ZU1 SYSTEM BLOCK DIAGRAM

PROJECT : ZU1

Quanta Computer Inc.

Size	Document Number	Rev
	GMCH HOST(1 of 7)	3B
Date:	Tuesday, April 10, 2007	Sheet 5 of 39

SDVO-DVI

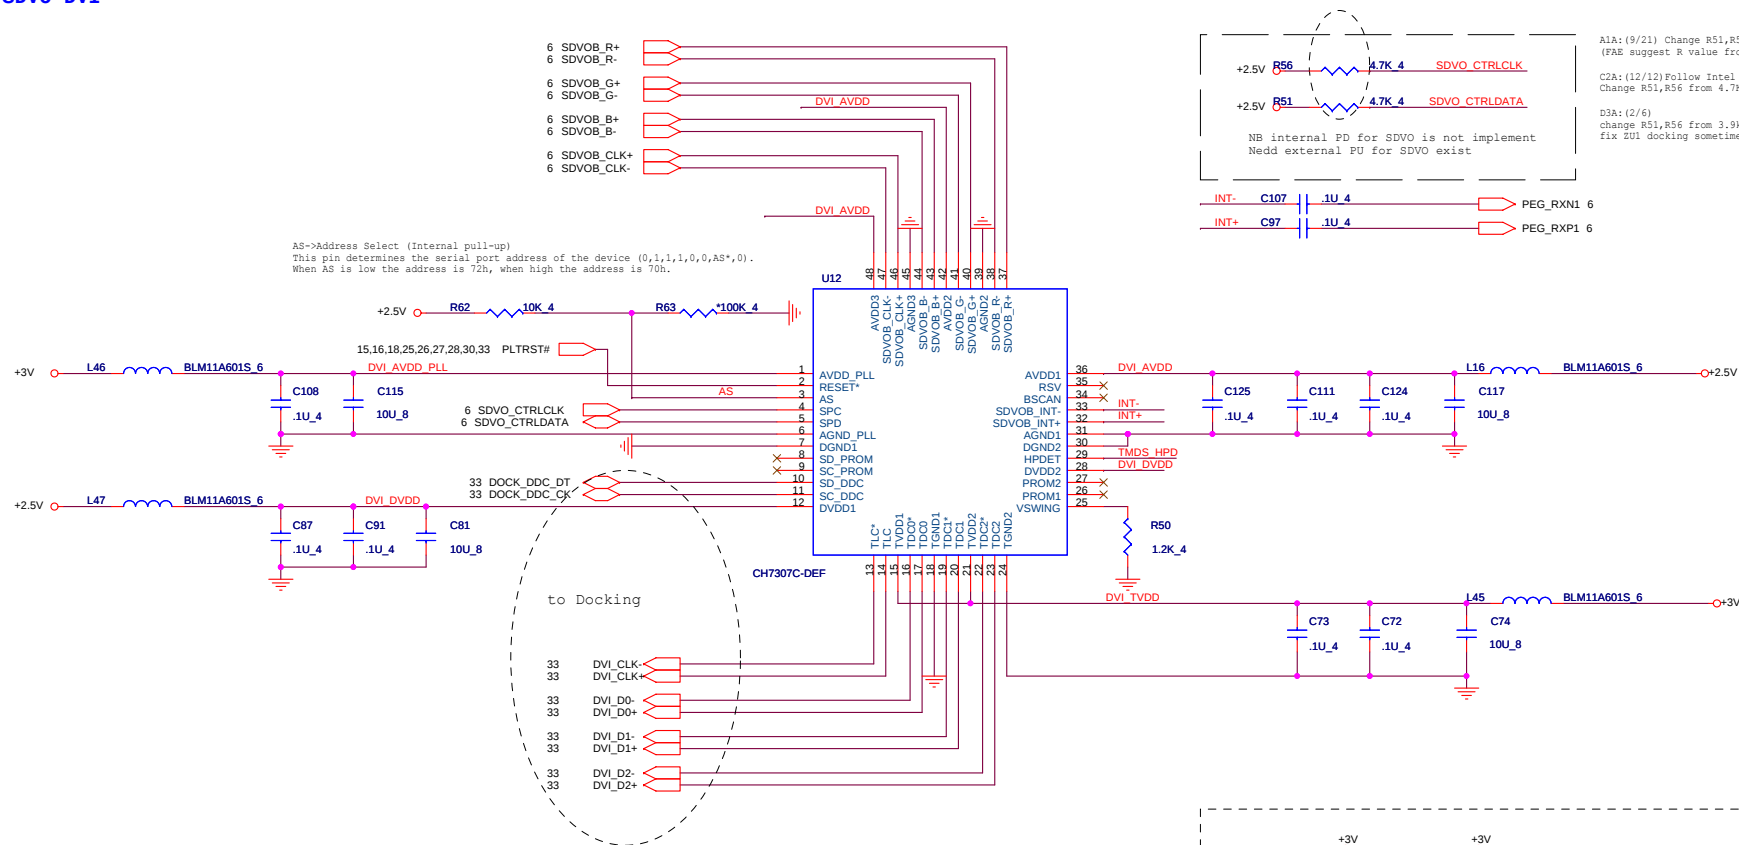
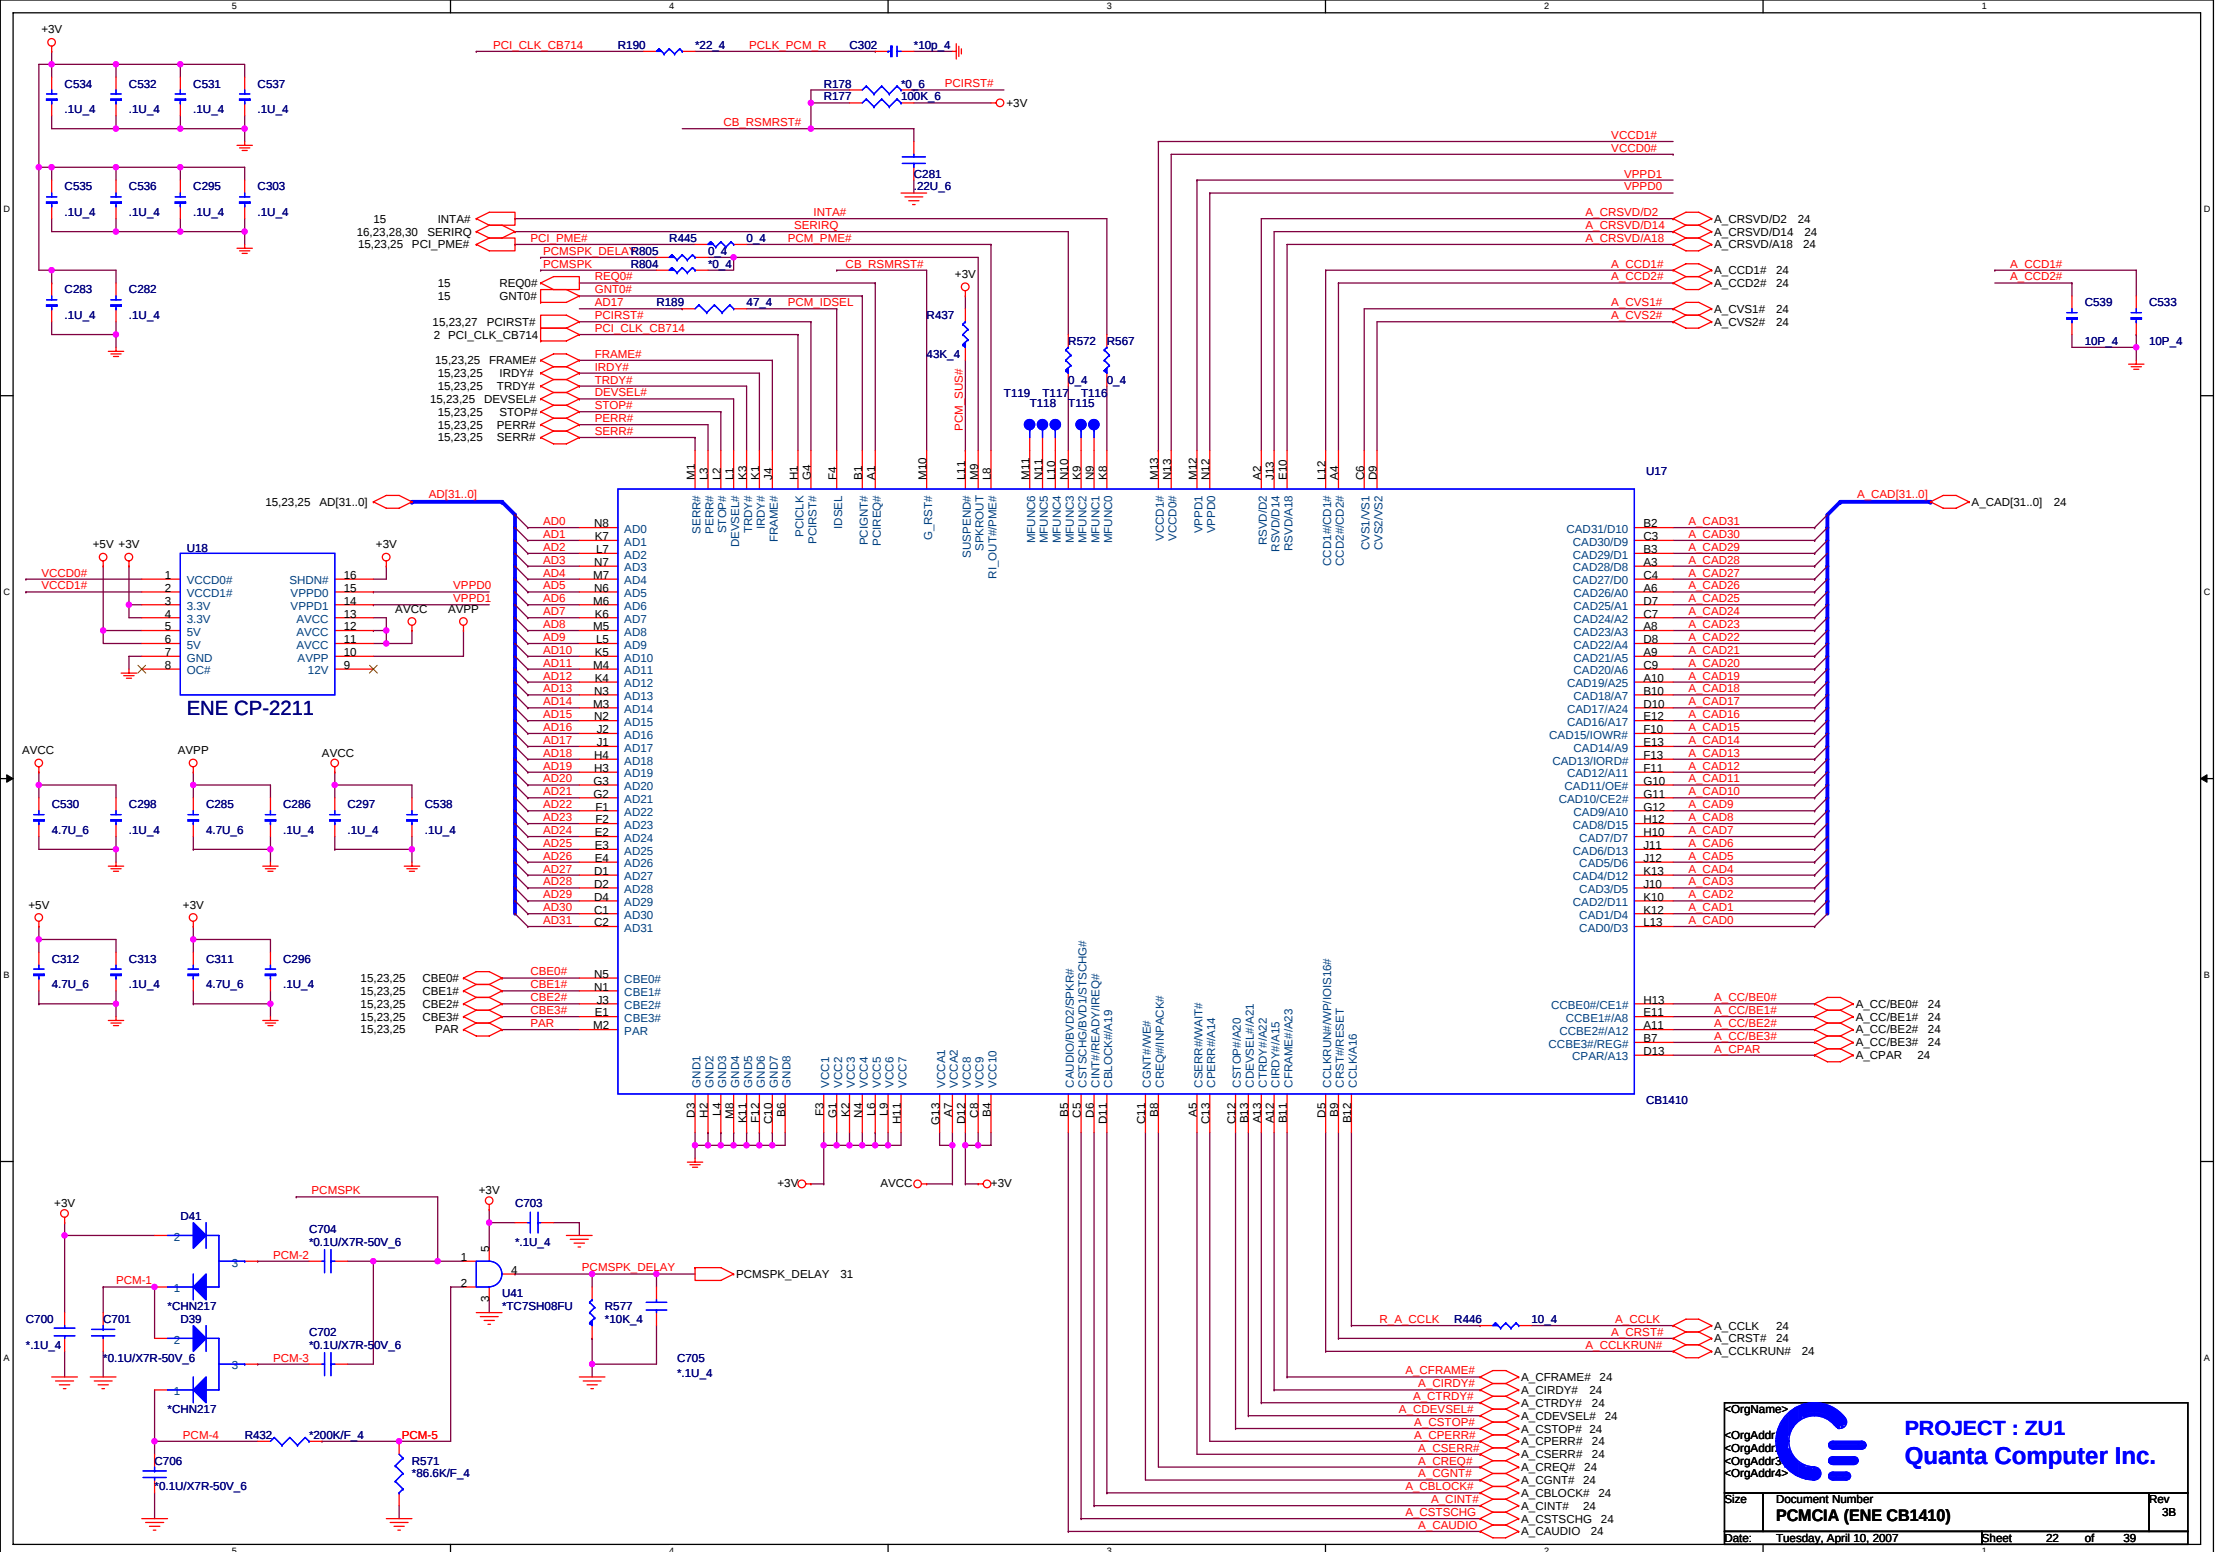
D3A: (1/30) remove U13,R68,R75,R73,C98
1/16 confirm with CHRONTEL FAE,
he said we can remove CH9001 (U13),
if ZUI need support HDCP,
just need change controller from CH7307 to CH7313.
CH7313 already integrated HDCP function, no need external EEPROM.

C2A:(12/22) confirm with FAE ->
Due to Intel VBIOS already integrate the EEPROM function.
ZU1 will remove the U11,R57,R52,C109 to save layout space.

HOLE

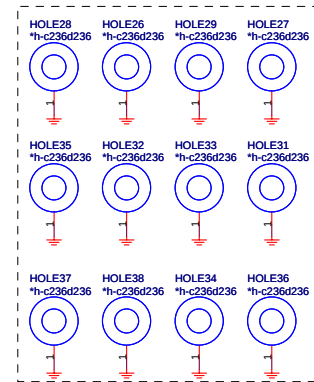
C2A: (12/28) change Hole17 type to improve thermal issue,
(change footprint to H-C276d94N-4)

D3A: (2/2) change Hole9 footprint

PROJECT : ZU1
Quanta Computer Inc.
SYSTEM 5V/3V (ISL6236)

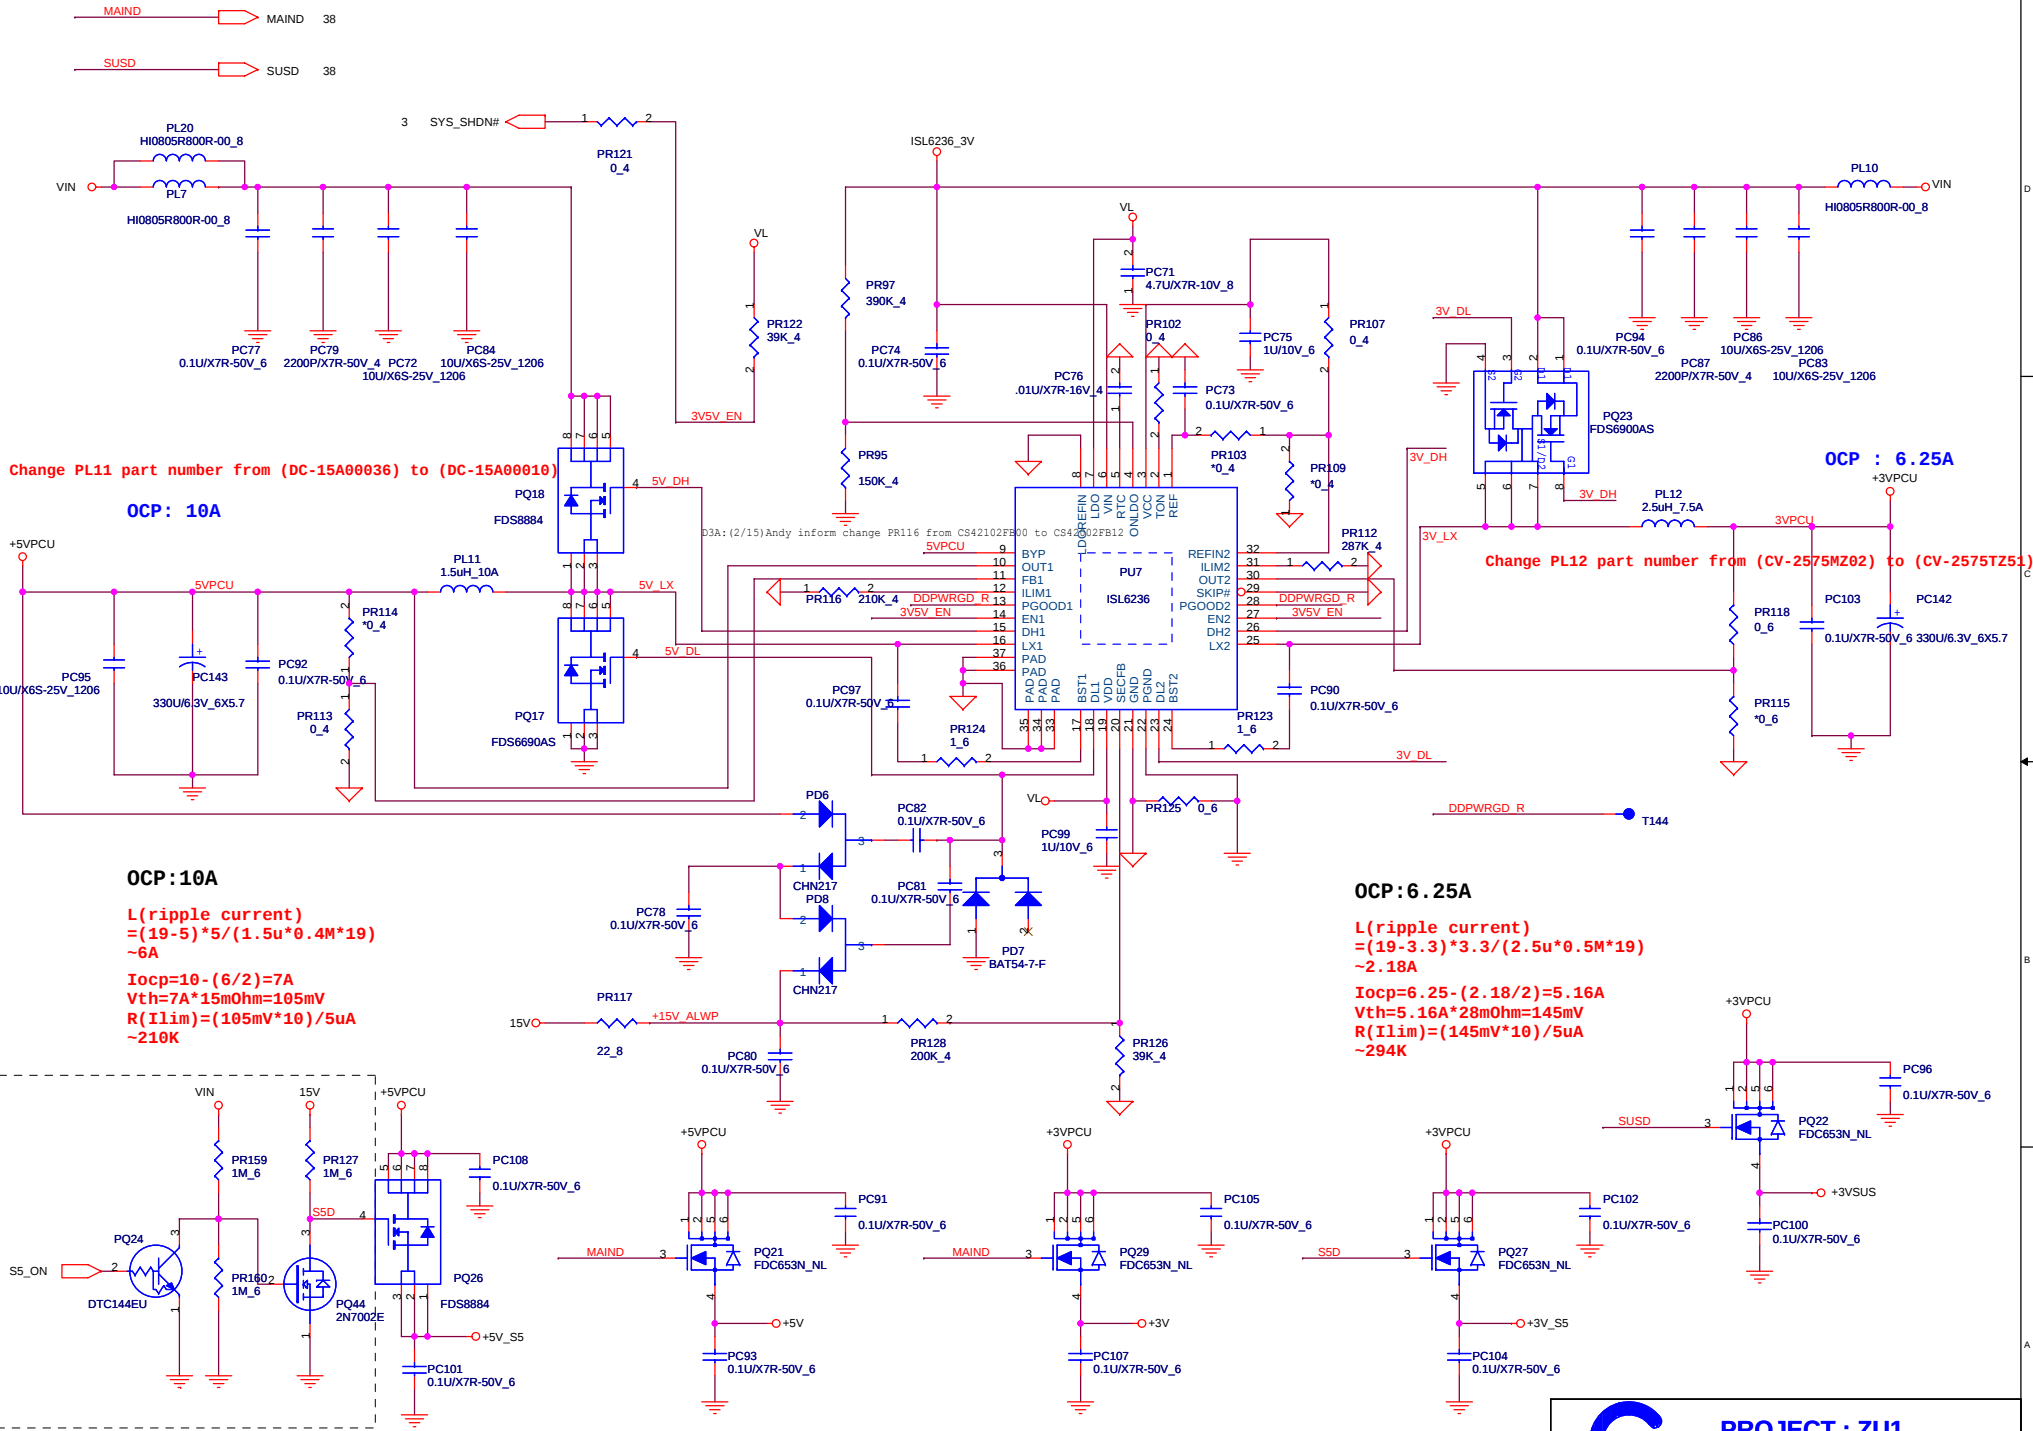
Change PL11 part number from (DC-15A00036) to (DC-15A00010)

$L(\text{ripple current}) = (19-5) * 5 / (1.5u * 0.4M * 19) \sim 6A$
 $I_{ocp} = 10 - (6/2) = 7A$
 $V_{th} = 7A * 15m\Omega = 105mV$
 $R(I_{lim}) = (105mV * 10) / 5uA \sim 210K$

$L(\text{ripple current}) = (19-3.3) * 3.3 / (2.5u * 0.5M * 19) \sim 2.18A$
 $I_{ocp} = 6.25 - (2.18/2) = 5.16A$
 $V_{th} = 5.16A * 28m\Omega = 145mV$
 $R(I_{lim}) = (145mV * 10) / 5uA \sim 294K$

C2A: (12/10) change S5_ON control circuit

B1C: (11/29) Change PQ26 from FDS6690AS (BAM6690022) to FDS8884 (BAM8884006)
